### THRUSH AIRCRAFT, INC.

## **SERVICE LETTER**

**No. SL-AG-111**

# ENGINE MOUNT AND MOUNT ISOLATOR INSPECTION AND REPAIR

Figure 2: Plug Installation

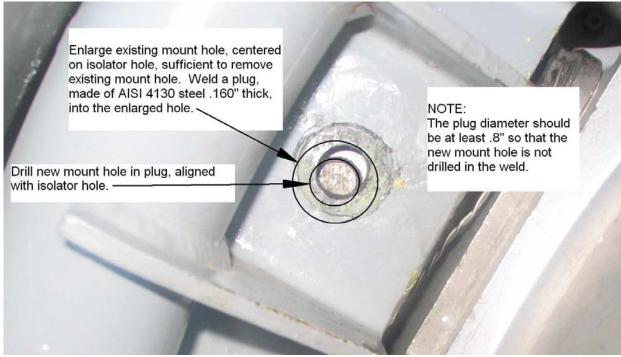
- 1. Misalignment: See figures 2 and 3.
- 2. Rubber damage: See figure 3.
